RM57Lx Microcontroller

Silicon Revision A

Silicon Errata

Literature Number: SPNZ214C
May 2014–Revised May 2016

Figure 2. Shared Input Channel in "Open" State

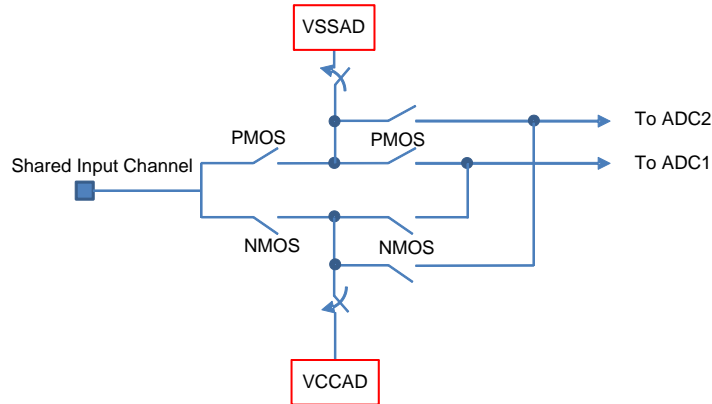
Issue This microcontroller (MCU) has two Analog-to-Digital Converters (ADCs). Some of the input channels are unique to ADC1 while some are shared between ADC1 and ADC2. [Figure 2](#) shows a block diagram of an input channel shared between ADC1 and ADC2.

The PMOS and NMOS switches are open indicating that this shared input channel is not currently being sampled either by ADC1 or by ADC2. Also, there are switches to VCCAD and VSSAD that are closed. If any current is injected into this analog input, any leakage through the open PMOS switch will be shunted to VSSAD. These switches to VSSAD and VCCAD are opened as soon as this shared input channel is being sampled by either ADC1 or ADC2.

1. Configure the two ADC modules such that their sampling periods do not overlap, or
2. Limit the shared analog input upper limit to be lower than $(V_{CCAD} - 0.3V)$. The PMOS leakage is reduced exponentially if the input is lower than $V_{CCAD} - 0.3V$.

Figure 3. Example ADC1/ADC2 Channel Connection

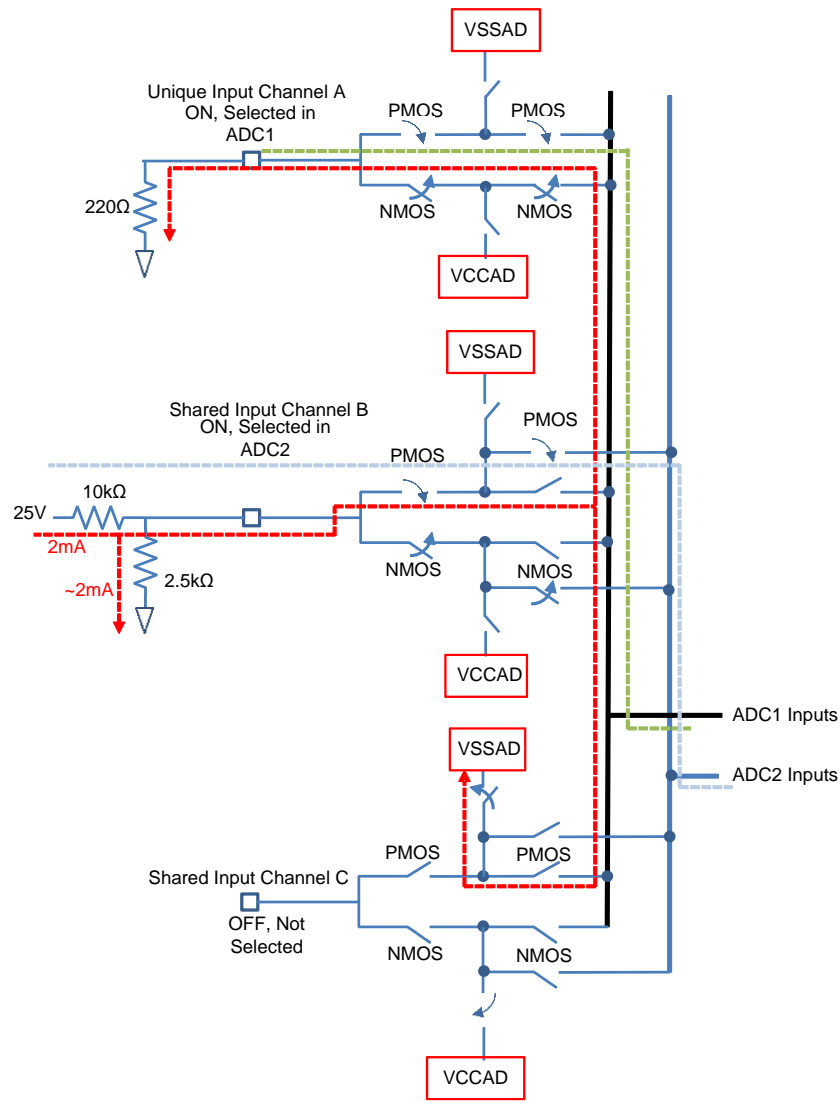
Figure 3 shows an example where a ADC1 is sampling input channel A which is unique to ADC1, and ADC2 is sampling input channel B, which is a shared-input channel. This is shown by the dashed green and light blue current paths.

Another current path is shown in dashed dark red. This is a current injected into channel B as the input level on terminal B is greater than $V_{CCAD} - 0.3V$. This is a parasitic current that passes through the "open" PMOS switch, and a part of this current flows to ground through the external 220 ohm resistor connected to input channel A. This causes an offset in the conversion result of channel A being sampled by ADC1.

1. Input voltage on a shared input channel being sampled by one ADC is $(V_{CCAD} - 0.3V)$ or higher, and
2. The second ADC samples another channel such that there is some overlap between the sampling windows of the two ADCs

An offset error is introduced in the conversion result of any channel if a current is being injected into a shared input channel.
